Grove Hill Road Pedestrian Safety and Accessibility Measures

Consultation Summary

January 2015

Contract No.	HW2013 NEC3	Drawn	LM
		Designed	LM
Scale	1:250 @ A1	Checked	CM
	Purpose CONSTRUCTION	Approved	OK
Drawing No.	14404-03-001/GA/001	Rev.	-
Date Drawn	NOVEMBER 2014	Date Issued	NOVEMBER 2014

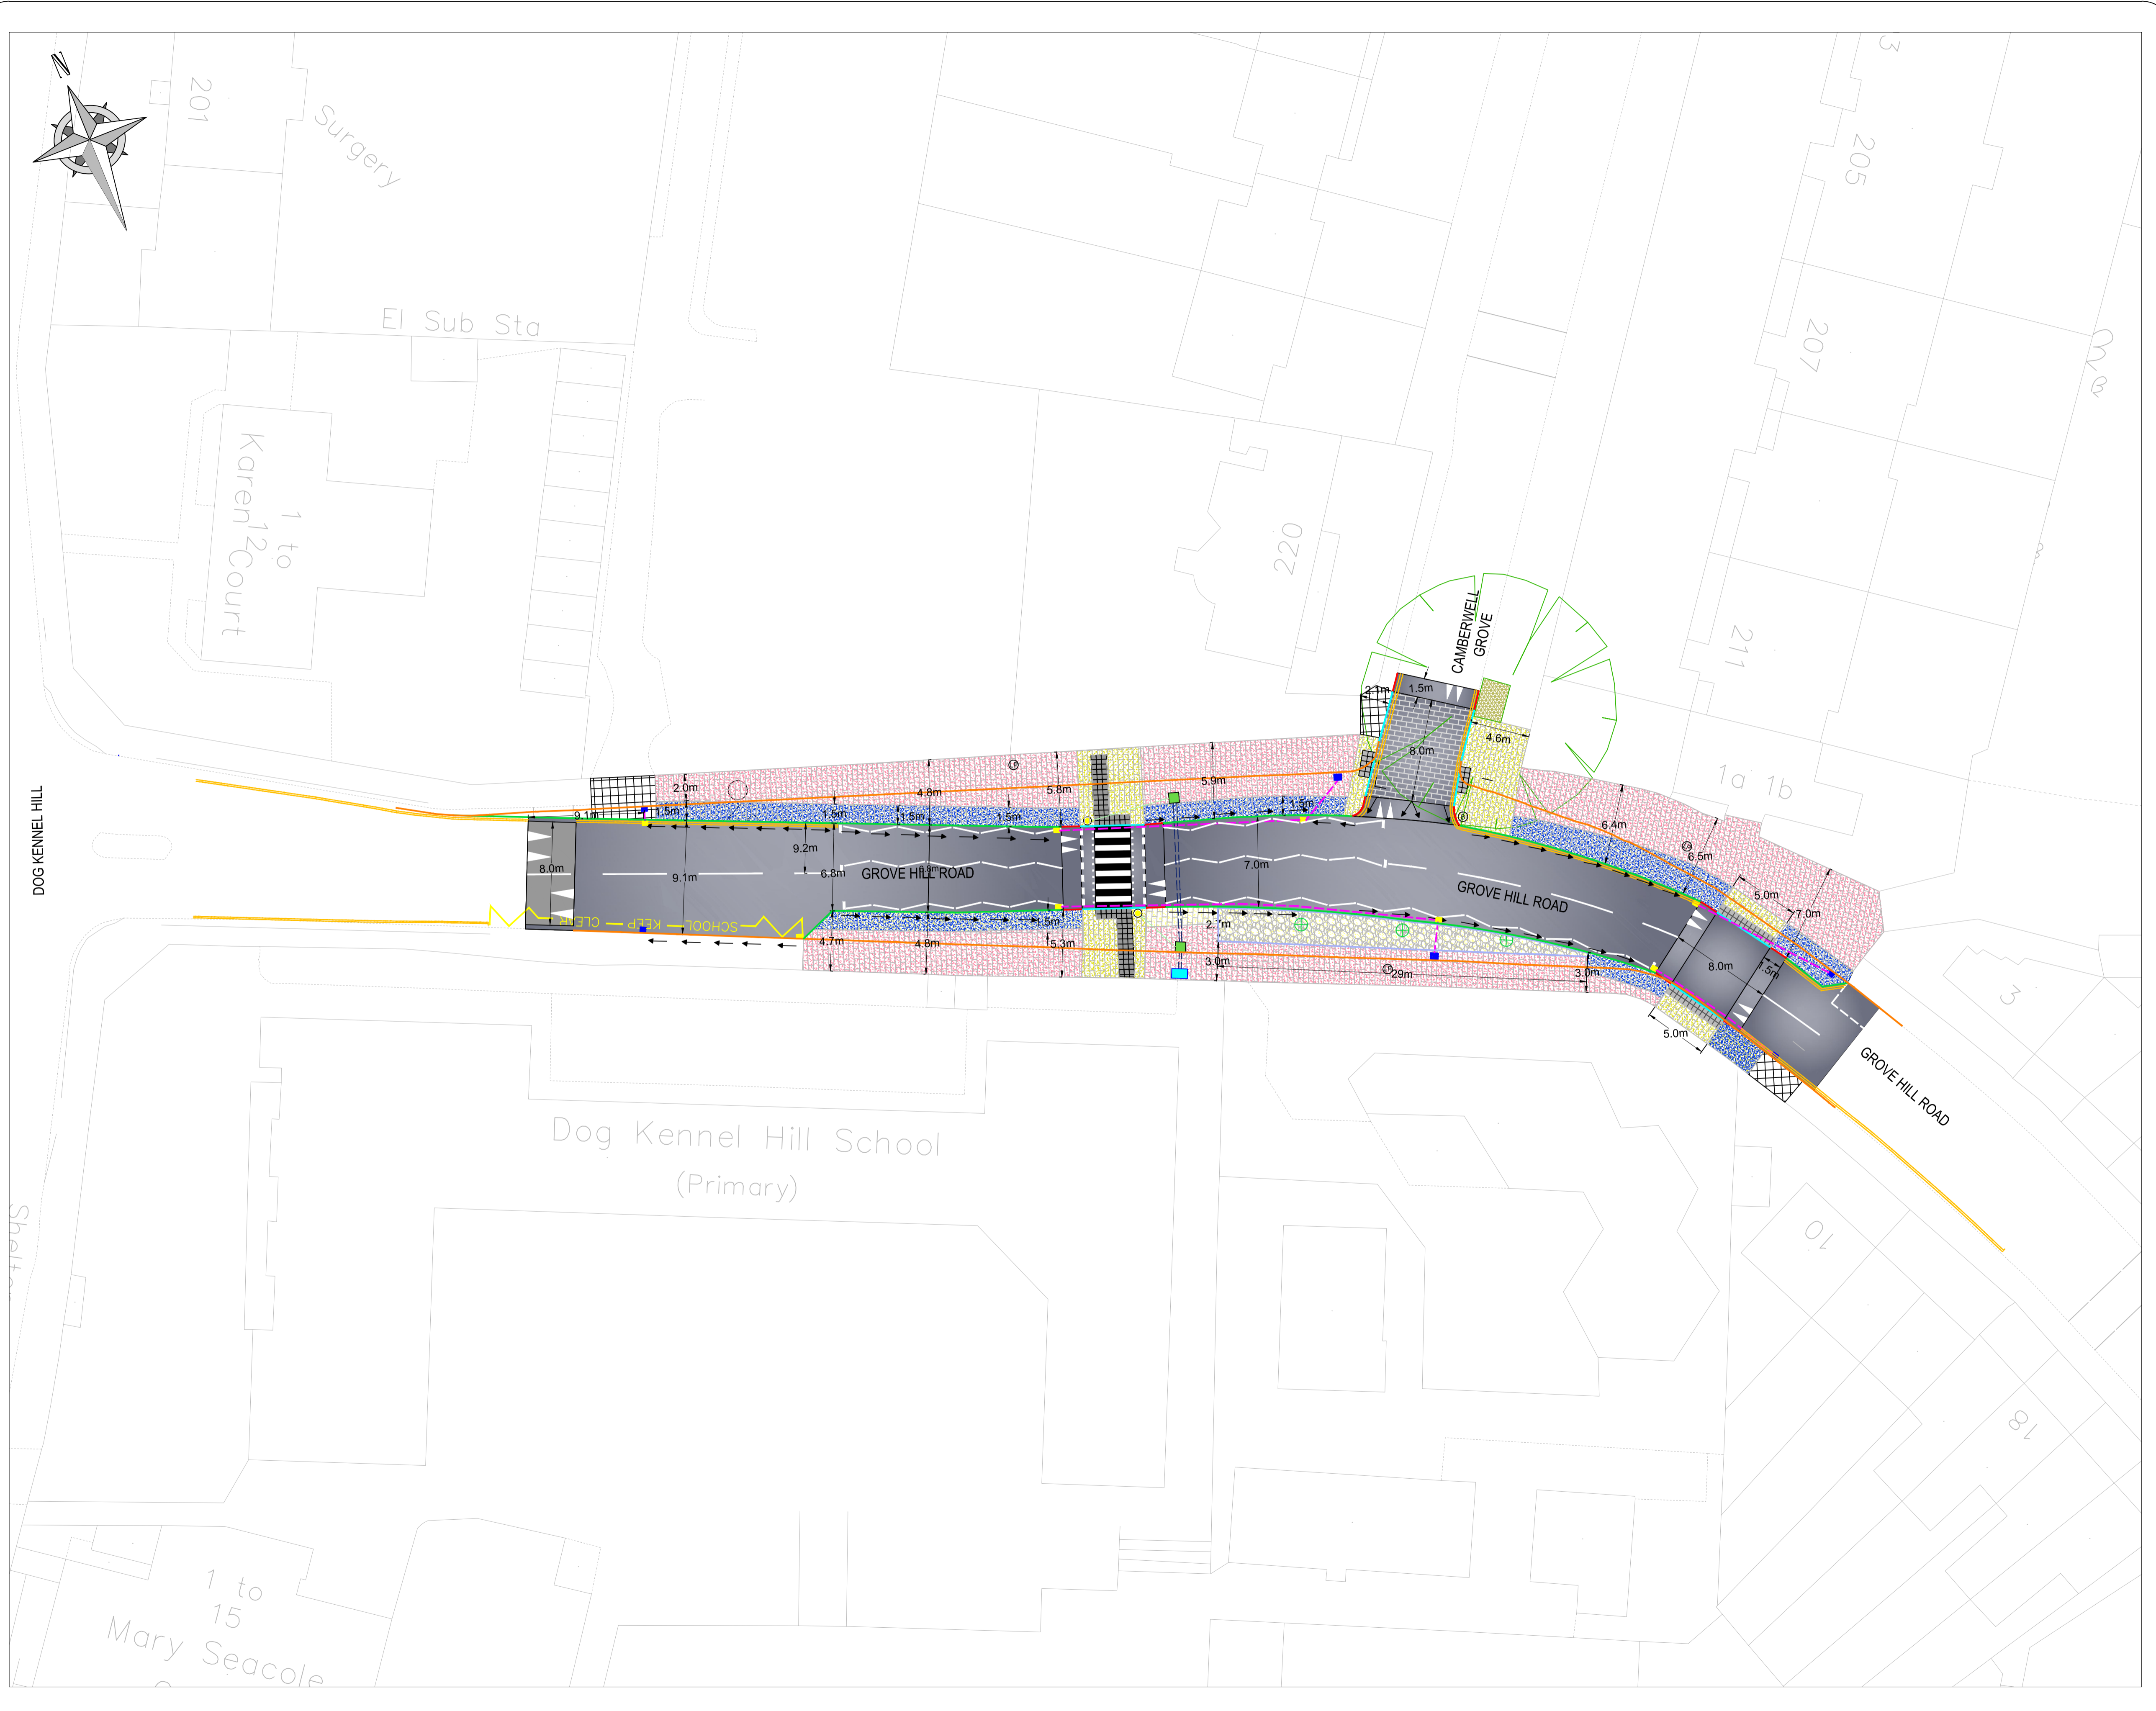
- 2.3.14 A number of concerns were raised about the height of the foliage in the proposed planter potentially obstructing drivers visibility of children approaching the zebra crossing when coming up the hill on Grove Hill Road.*

*In response, the species of plants to be installed in the planter are to be carefully selected to ensure that foliage does not obstruct the forward visibility of

drivers traversing up Grove Hill Road on approach to the zebra crossing. However it must be noted that there is actually an adequate forward visibility splay of 40m past the extents of the planter from the crossing location, which is far greater than the minimum 25m required for a 20mph carriageway.

Project		GROVE HILL ROAD RAISED ZEBRA CROSSING CGS 2014-2015			
Title		DESIRELINE SURVEY			
Contract No.	HW2013 NEC3	Drawn	UM		
Scale	N.T.S.	Purpose	INFORMATION	Checked	CM
Drawing No.	14401-03-001/DS/001	Approved			
Date Drawn	OCTOBER 2014	Date Issued	OCTOBER 2014

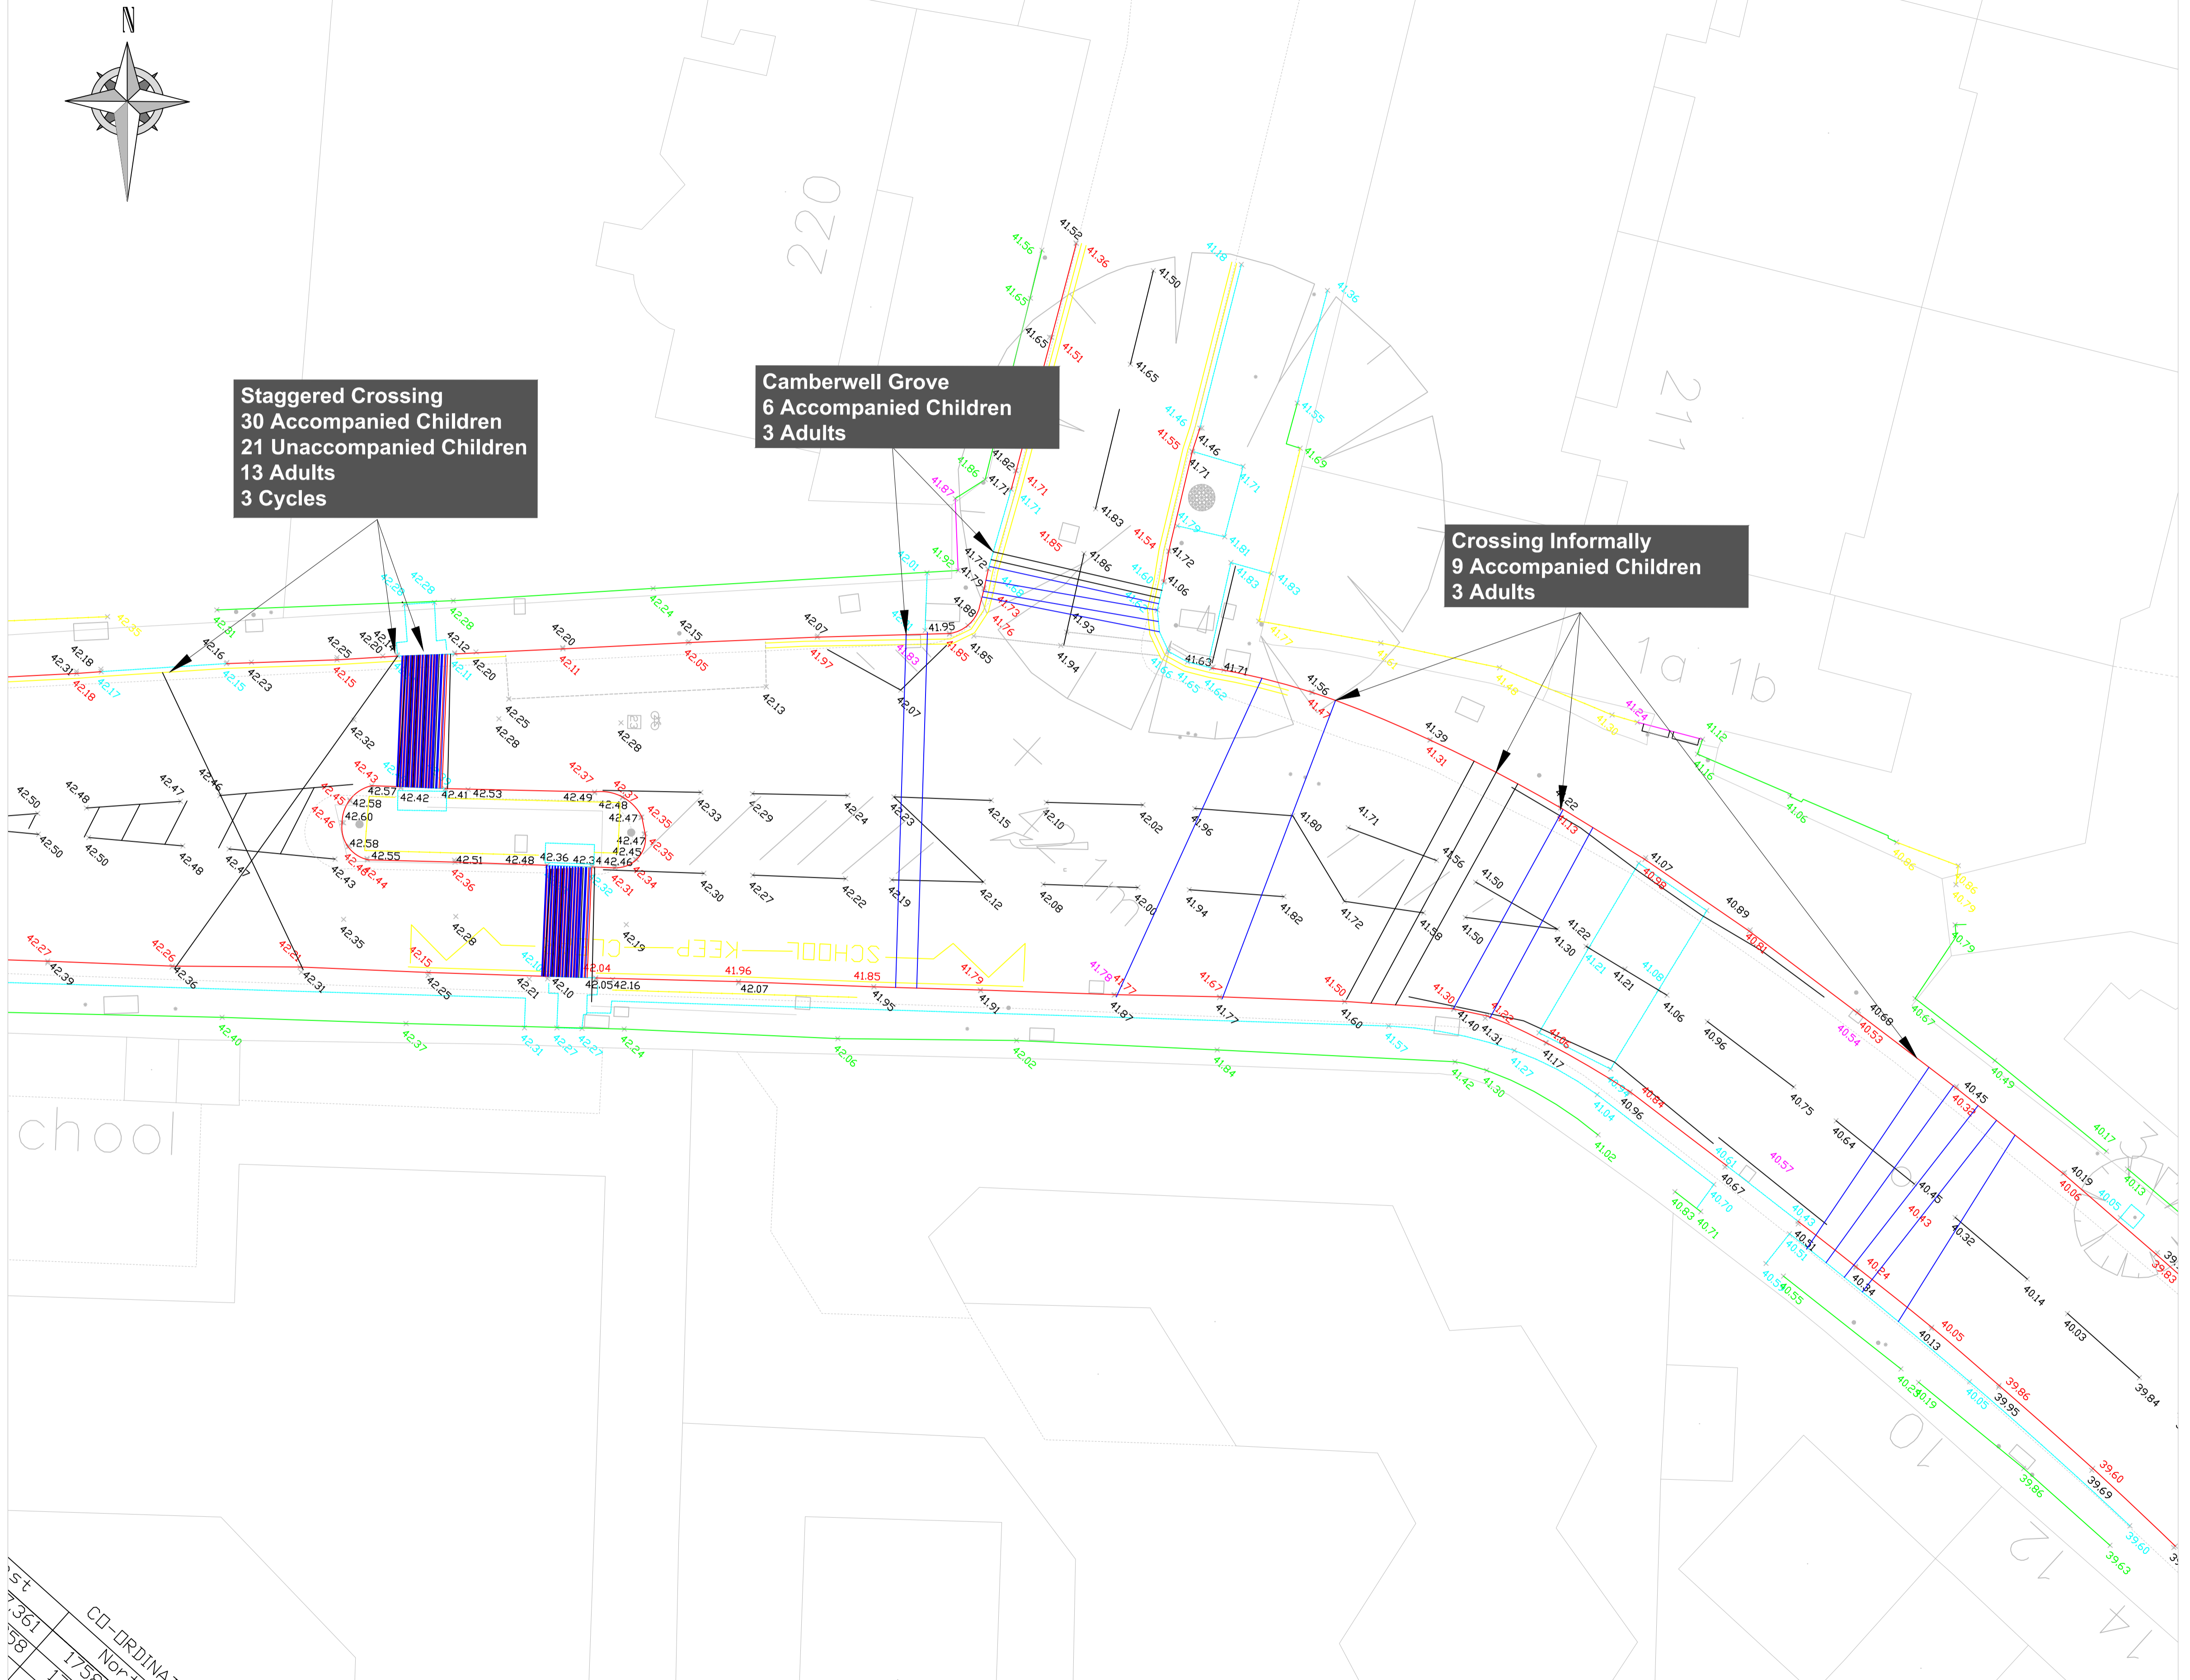
2.3.17 A number of requests were made for converting the proposed raised carriageway table and pedestrian crossing point adjacent to Lettsom Gardens into a zebra crossing. *

* In response, a peak time site survey was undertaken to identify the crossing behaviour of pedestrians between the area bounded by the main pedestrian entrance into the school and Lettsom Gardens. This survey provided key evidence for assessing where the majority of pedestrians cross the road. The survey plan can be viewed in Appendix E.

It was clear from the survey that the majority of pedestrians cross Grove Hill Road at the existing staggered uncontrolled crossing point adjacent to the school entrance, with only a minimal number of pedestrians crossing Grove Hill Road adjacent to Lettsom Gardens.

Therefore in light of the survey analysis, the installation of a zebra crossing facility adjacent to the Lettsom Gardens entrance is not warranted due to the low number of pedestrians that would use this facility compared with the heavy pedestrian volumes and pedestrian desire line adjacent to the school entrance. It is clearly evident that a zebra crossing facility will benefit far more pedestrians at this location as there will now be a single movement to cross the carriageway, rather than the two stage crossing associated with the existing refuge island.

In accordance with the above, the proposed informal pedestrian crossing point on a raised table adjacent to Lettsom Gardens is the most appropriate measure to cater for the number of pedestrians and desire line across Grove Hill Road at this location. This facility in conjunction with the parking restrictions will significantly improve sightlines, accessibility and reduce traffic speeds, which are the main issues experienced by pedestrians at this location.
